AMENDMENT OF SOLICITATION/MODIFICATION OF CONTRACT				1. CONTRACT ID CODE	PAGE OF PAGES 1 110
2. AMENDMENT/MODIFICATION NO. 0003		3. EFFECTIVE DATE 27 OCT 2020	4. REQUISITION/PURCHASE REQ. NO.	5. PROJECT NO. (If applicable)	
6. ISSUED BY CODE U.S Army Corps of Engineers, Los Angeles Dist CESPL-CT-E, East Region Branch 915 Wilshire Blvd. Los Angeles, CA 90017		7. ADMINISTERED BY (If other than Item 6) SEE ITEM 6	8. NAME AND ADDRESS OF CONTRACTOR (No., street, county, State and ZIP Code)		
CODE		FACILITY CODE	(X)	9A. AMENDMENT OF SOLICITATION NO. W912PL-21-B-0002	
			<input type="checkbox"/>	9B. DATED (SEE ITEM 11) 18 September 2020	
			<input type="checkbox"/>	10A. MODIFICATION OF CONTRACT/ORDER NO.	
			<input type="checkbox"/>	10B. DATED (SEE ITEM 13)

FY18 GROUND TRANSPORT EQUIPMENT FACILITY, FORT HUACHUCA, AZ

GROUND TRANSPORTATION EQUIPMENT BUILDING (GTBE) FORT HUACHUCA
AMENDMENT 0003 SUMMARY OF CHANGES

SHEET
IDENTIFICATION
A-102

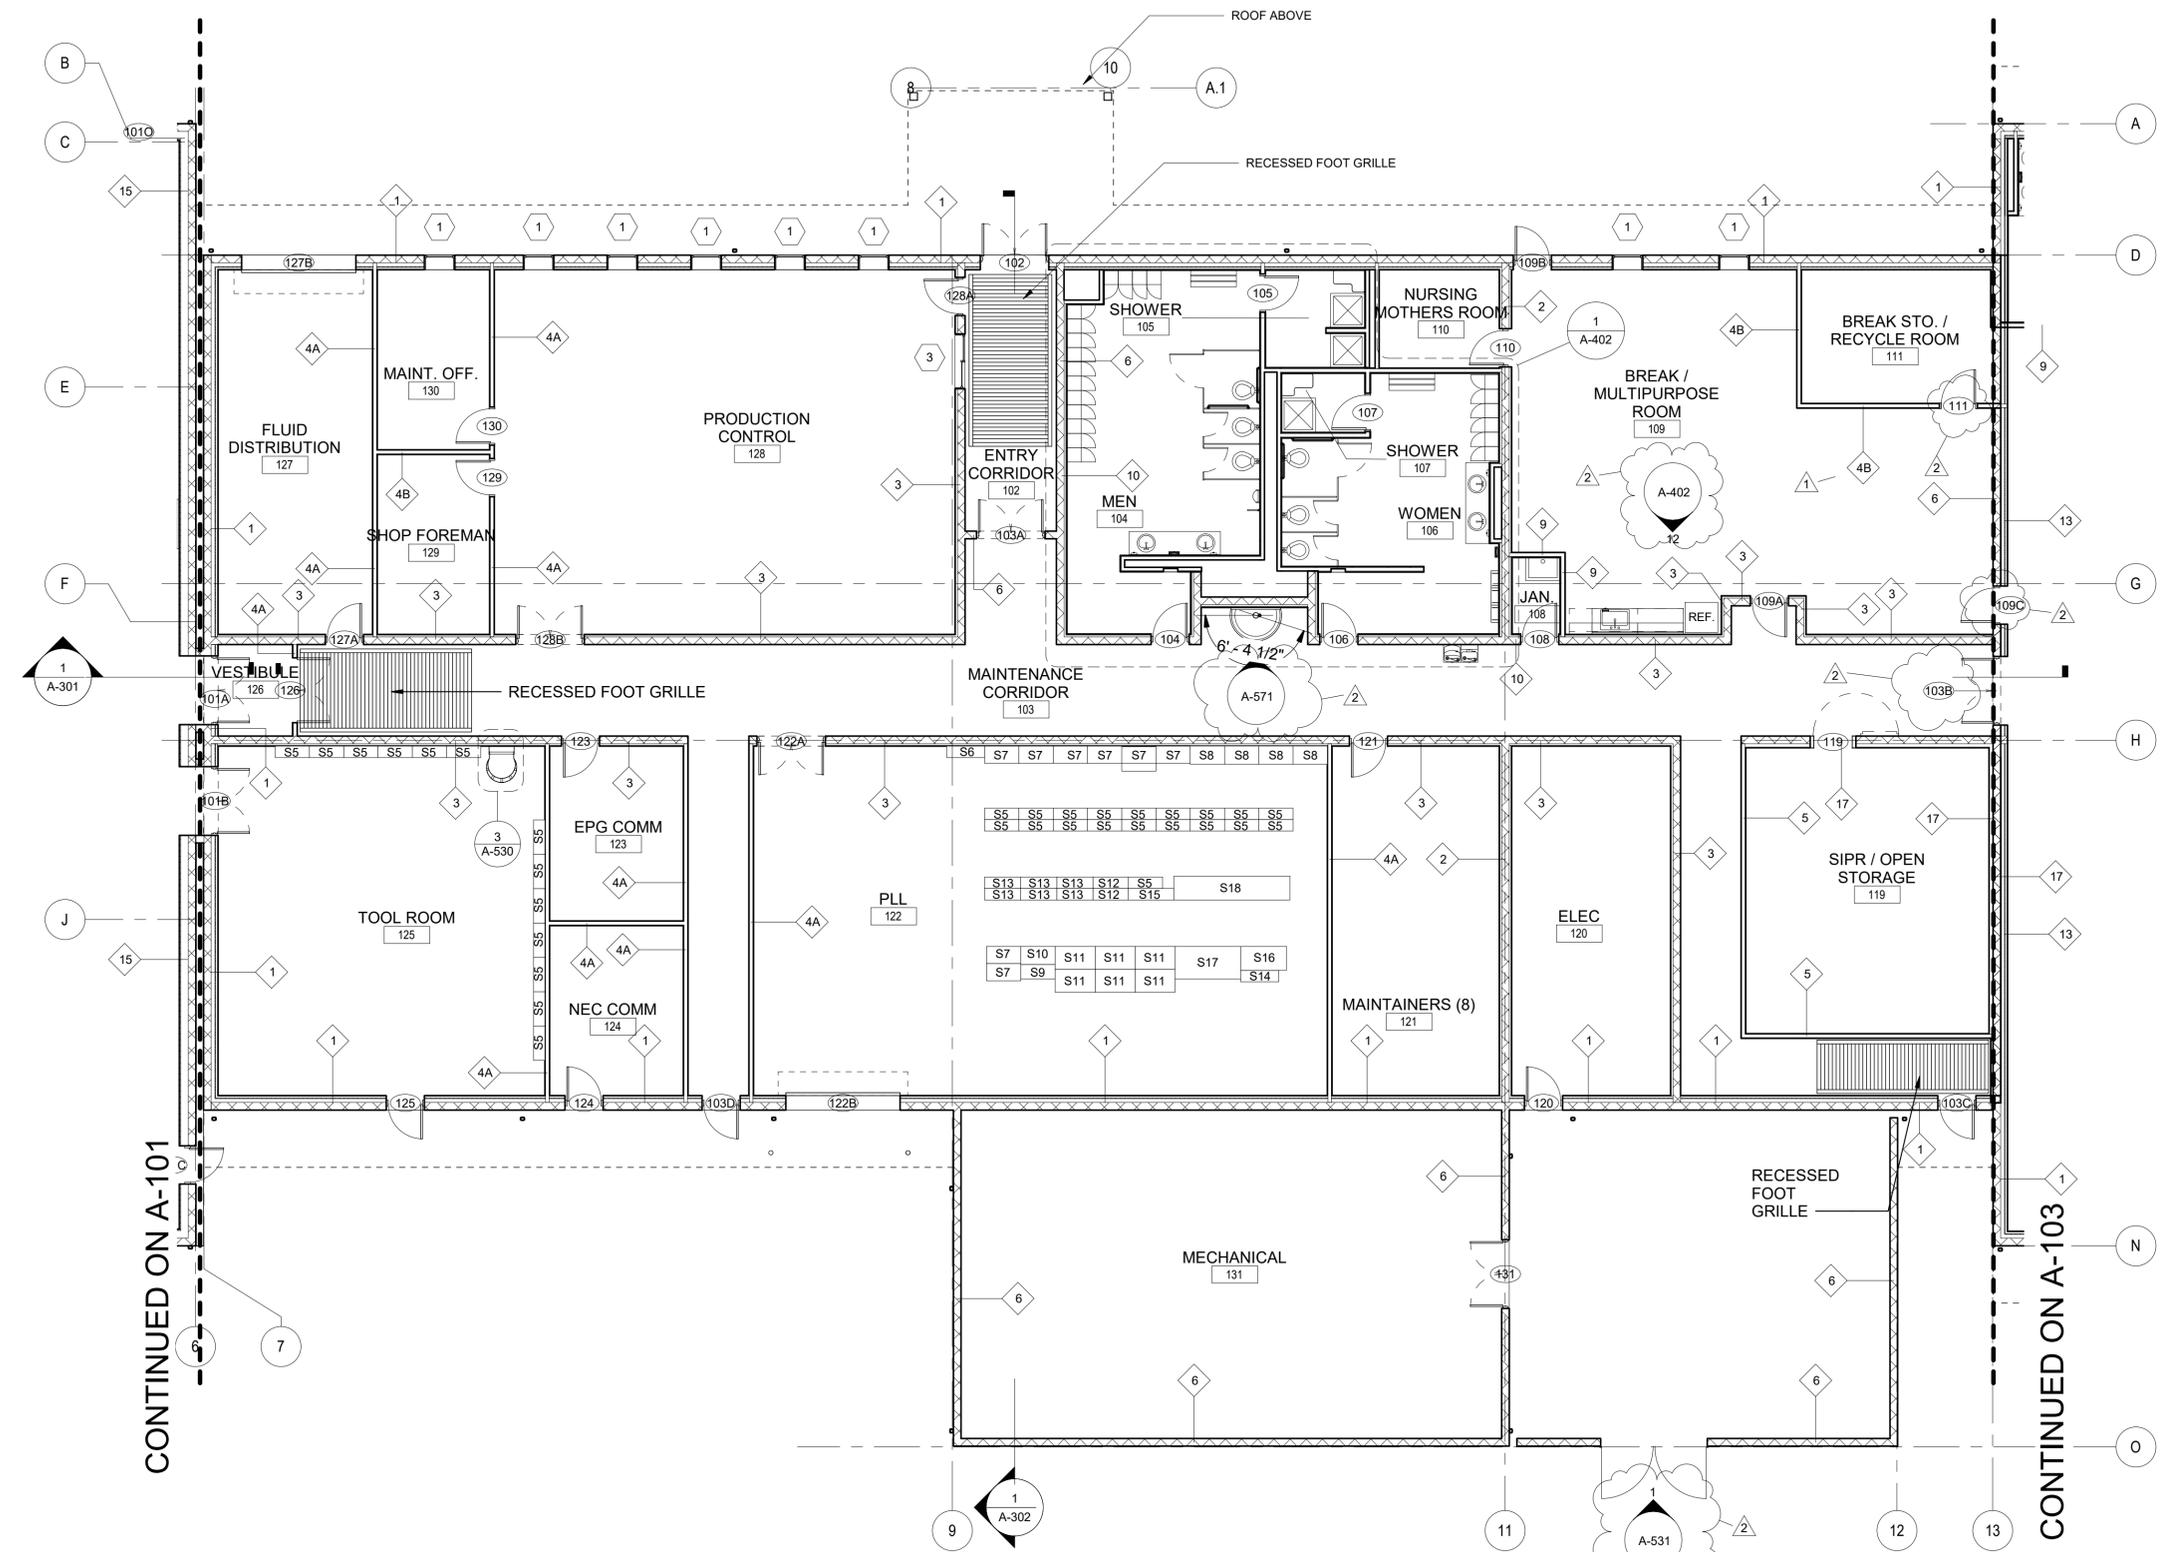
6. Revise Drawing A-102 and add Drawing A-102a.
7. Revise Drawing A-620; A-640 and A-641.
8. Revise Drawing M-602 clarifying "Option" requirements.
9. Revise E-601 Note for wire size from DP-1 to XP-1.

NOTE: CONFIRM FINAL LOCATIONS OF SHELVING UNITS WITH CUSTOMER AND COR.

SHEET ID T-101

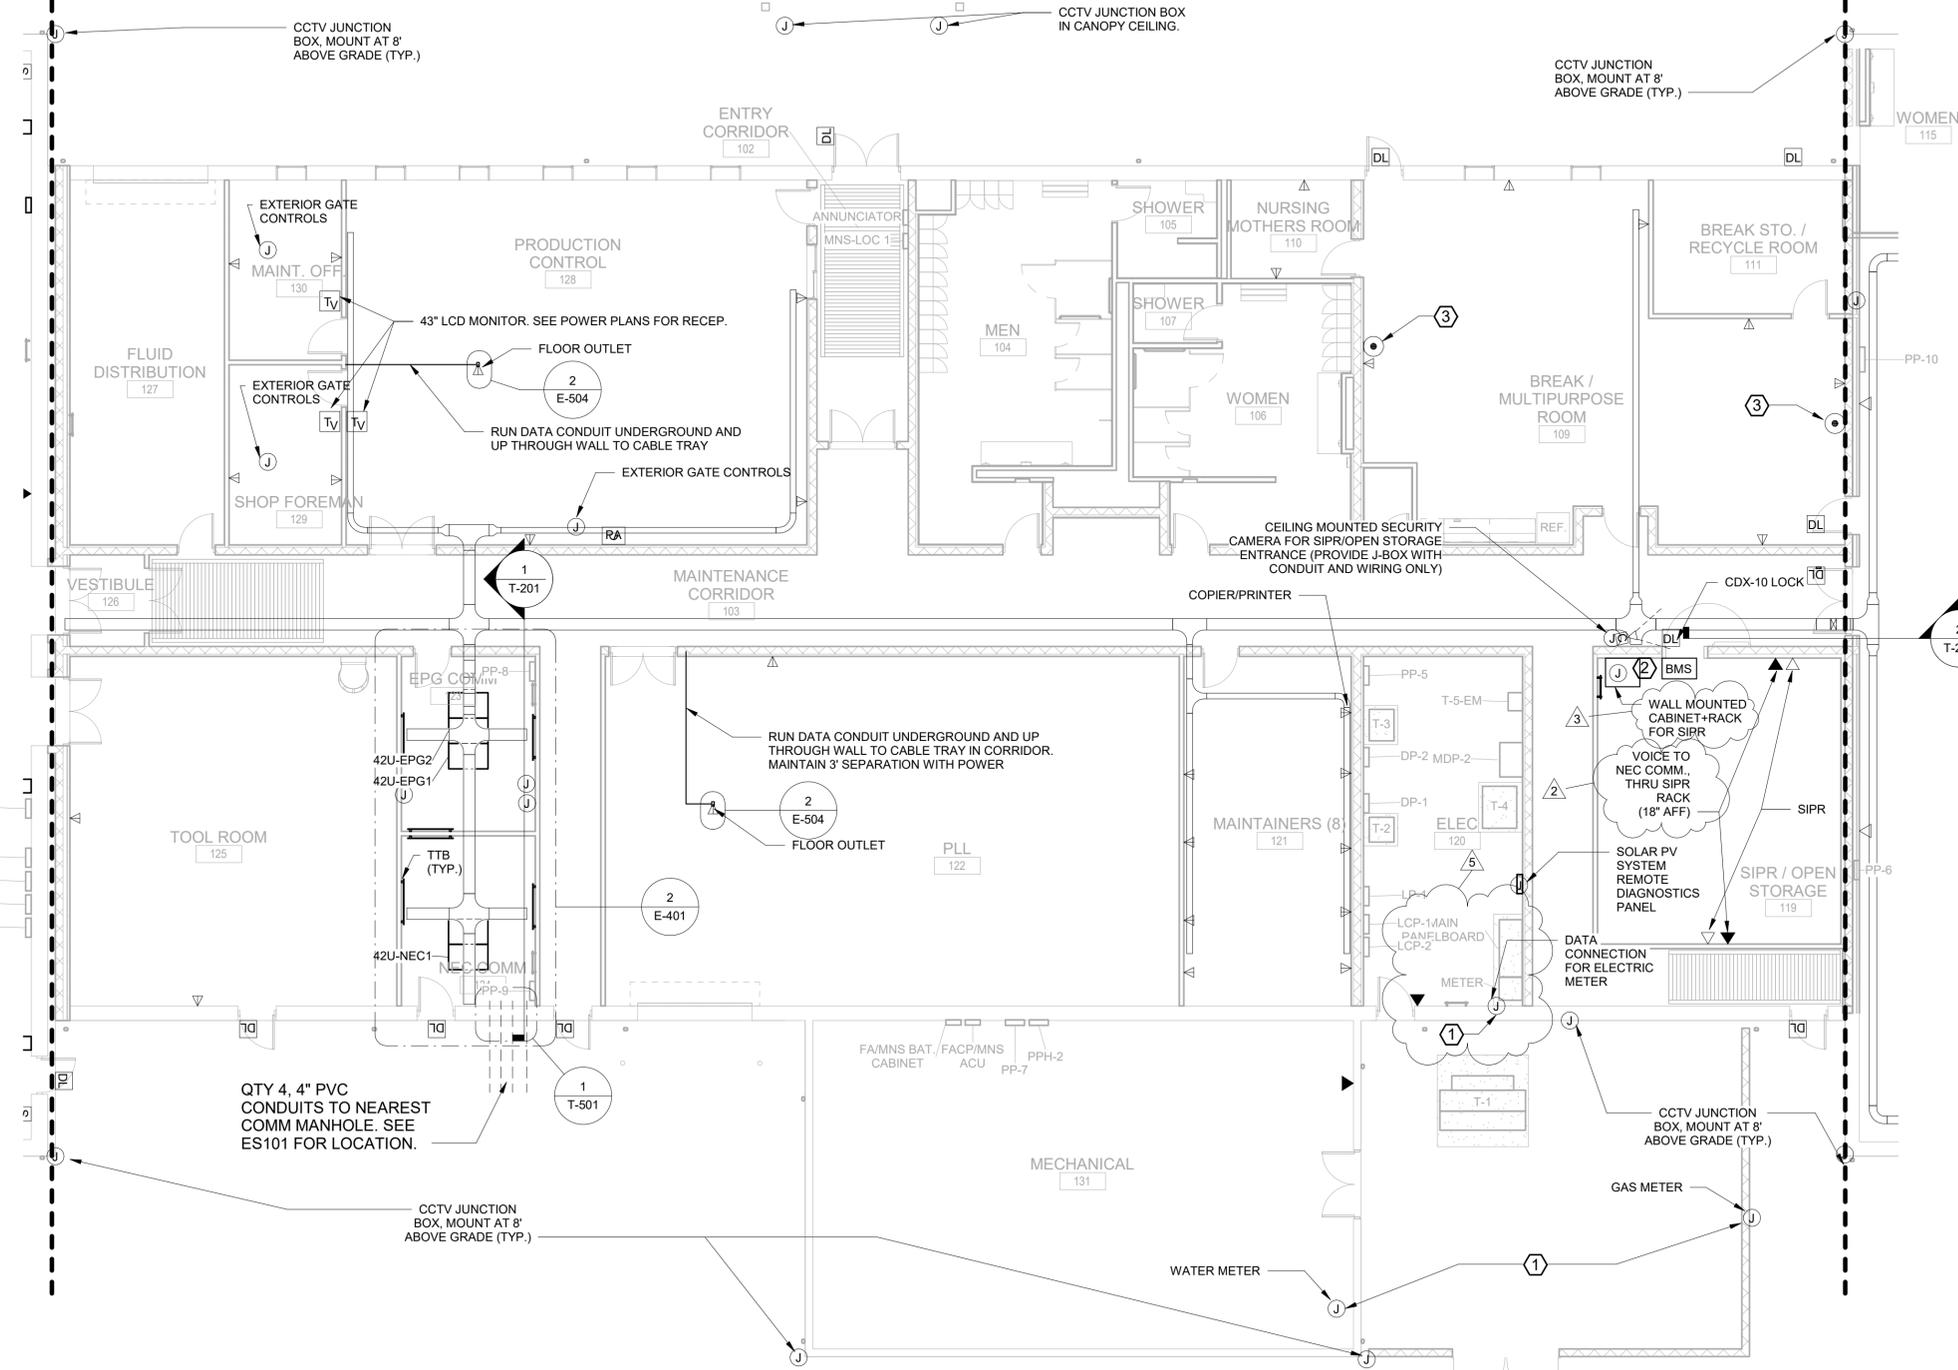
10. Revise Drawing FA-601 adding Note 6 on Fire Alarm Panel requirement (Monaco).
11. Revise a series of Electrical drawings; E-001; EP-102; EG-102; E-401; E-402; E-504; 101; T-102; T-103; T-501; T-502; T-601.

07 OCT 2020	DATE
1	MARK
1	CLARIFY ACS SCOPE
	DESCRIPTION

- CONTRACTOR SHALL FURNISH AND INSTALL ELECTRONIC ACCESS CONTROL SYSTEM, TO INCLUDE ALL ELECTRONIC DOOR HARDWARE, POWER SUPPLIES, AND CONTROL PANEL. POWER SHALL BE AT 120 V. ALL COMMUNICATIONS CONDUITS SHALL FEED BACK TO THE EPG COMMUNICATIONS ROOM. PROVIDE CARD READER/KEYPAD INTEGRAL WITH LATCH ON EACH DOOR INDICATED WITH THE DOOR LOCK SYMBOL. SEE DETAIL 2/T-501.

SHEET ID
T-102

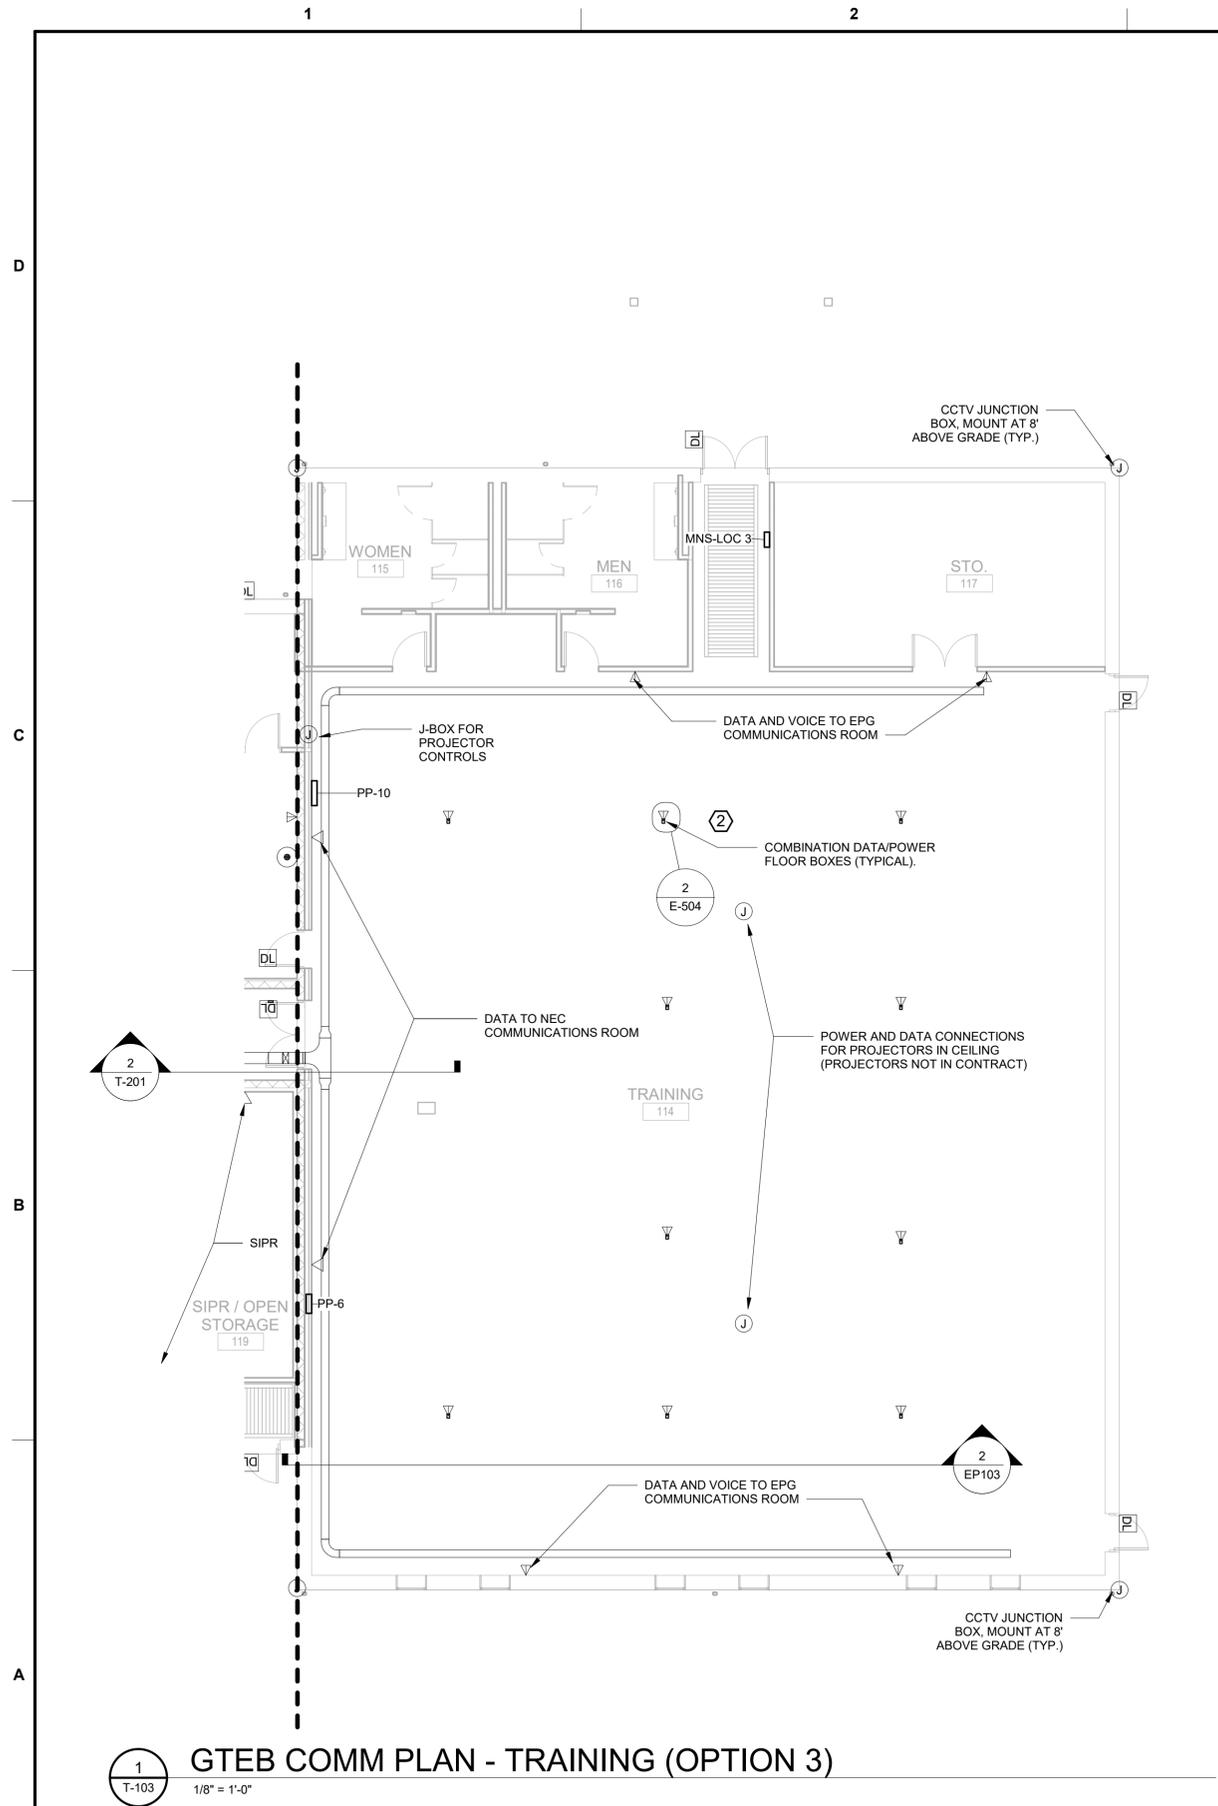
DATE	DESCRIPTION
07 OCT 2020	CLARIFY ACS SCOPE
07 OCT 2020	RELOCATE MAIN PANELBOARD, NEC 110.26(C)(2)
07 OCT 2020	CLARIFY EQUIPMENT CABINET AND RACK
07 OCT 2020	DATA OUTLET QTY CLARIFY

- DVR SHALL BE CAPABLE OF STORING CCTV VIDEO FOR 30 DAYS.
- CONTRACTOR SHALL FURNISH AND INSTALL ELECTRONIC ACCESS CONTROL SYSTEM, TO INCLUDE ALL ELECTRONIC DOOR HARDWARE, POWER SUPPLIES, AND CONTROL PANEL. POWER SHALL BE AT 120 V. ALL COMMUNICATIONS CONDUITS SHALL FEED BACK TO THE EPG COMMUNICATIONS ROOM. PROVIDE CARD READER/KEYPAD INTEGRAL WITH LATCH ON EACH DOOR INDICATED WITH THE DOOR LOCK SYMBOL. SEE DETAIL 2/T-501.

SHEET ID T-501

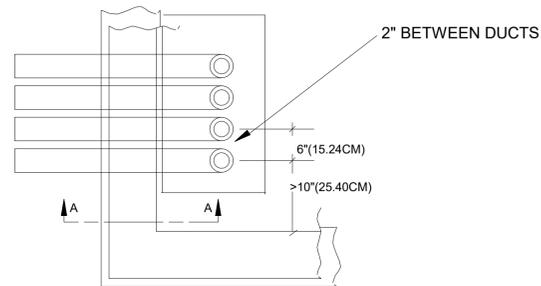
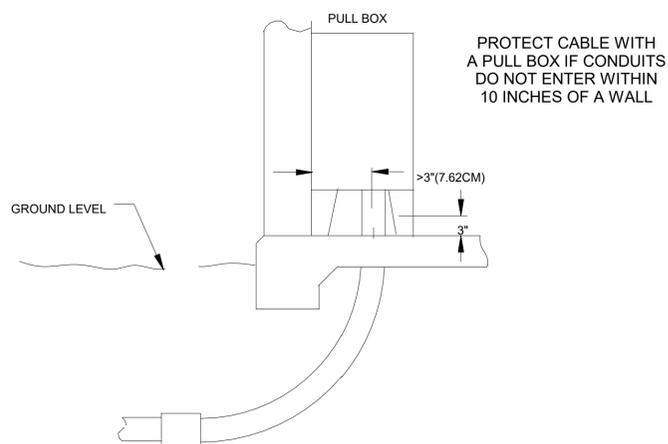
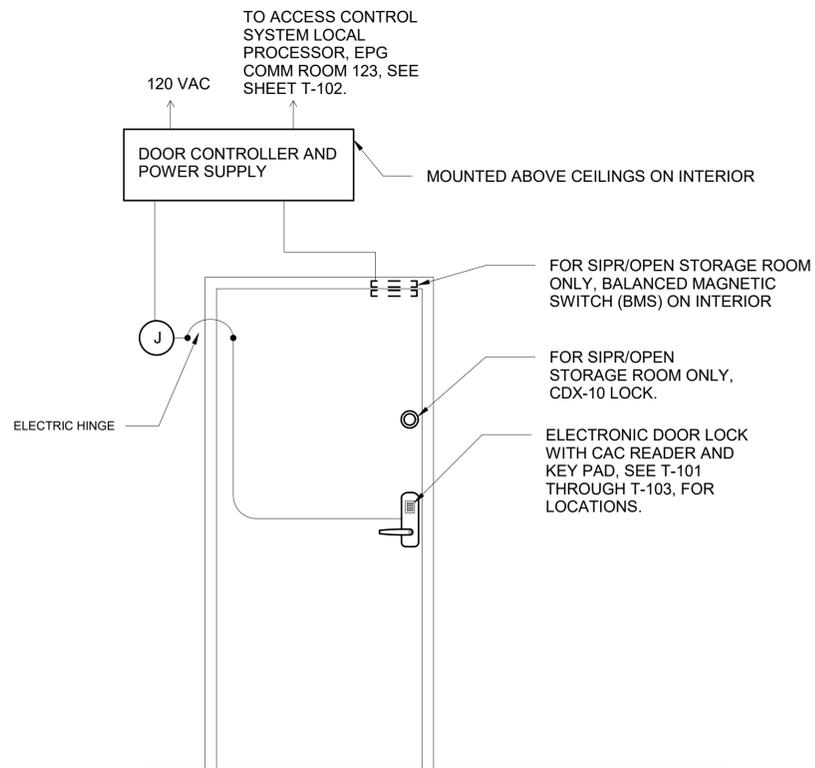
MARK	CLARIFY ACS SCOPE	DESCRIPTION	DATE
1			07 OCT 2020

1. EXTERIOR COMPONENTS SHALL BE WEATHERPROOF.
2. PROVIDE THIS DOOR LOCK CONFIGURATION AT EACH LOCATION WHERE A DOOR LOCK IS INDICATED ON SHEETS T-101 THROUGH T-103, AND EP111 (FOR STORAGE BUILDINGS).
3. PROVIDE THIS DOOR LOCK CONFIGURATION AT THE PEDESTRIAN DOORS TO THE HAZMAT AND POL STORAGE BUILDINGS. MOUNT DOOR CONTROLLER AND POWER SUPPLY ON THE WALL SPACE ON THE INTERIOR OF THE STORAGE ROOMS. ENCLOSURES SHALL BE EXPLOSION PROOF IN THESE BUILDINGS. FOLLOW SPEC SECTION 28 10 05.
- 4.
